Office Action Summary

10/718,537

GOULD ET AL.

FIG. 1

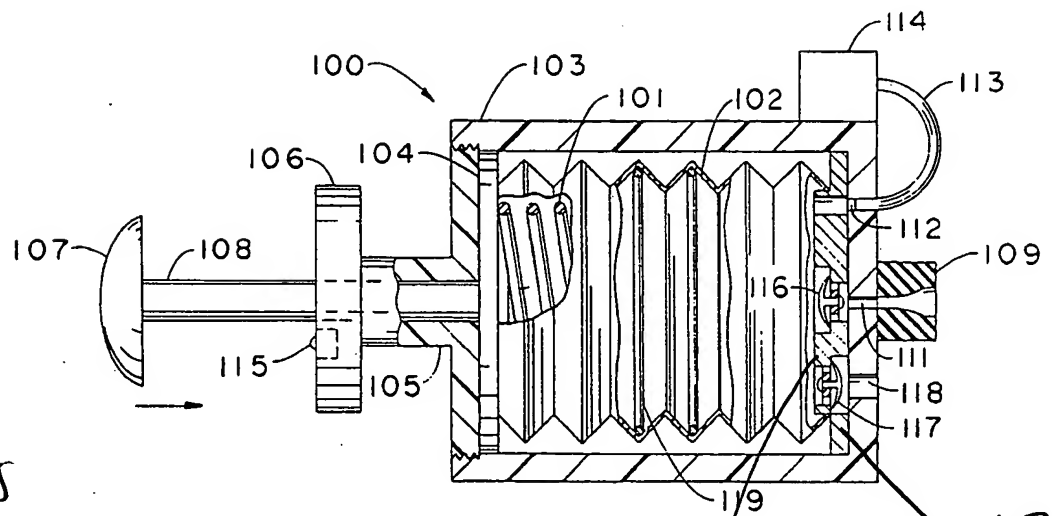
Kush et al. in Figure 1 teaches a vacuum system comprising a flexible container (102) having a generally rigid base wall (104) defining a first end of the container (102), a generally elongated and compressible cylindrical side wall (side wall of bellows 102) extending away from the base wall (104), and an opening (shown not enumerated, in which the valve plate is inserted into the end of the bellows 102) disposed at a second end of the container (102). A cap (see marked up Figure 1) is removably attached and sealed to the opening (shown not enumerated). The cap has a first coupler (see axial engaging surface on which the bellows opening is mounted) and includes a means (inner surface) for receiving a biasing force urging the cap away from the opening (shown not enumerated). A helically wound spring (101) is disposed within the container (102) and extends between the cap (see marked up Figure 1) and the base wall (104). Valves (116, 117) communicate with the first coupler and are mounted on the cover (see marked up Figure 1).

Examiner's
Marked
Up Figure
Please Include
in Office Action
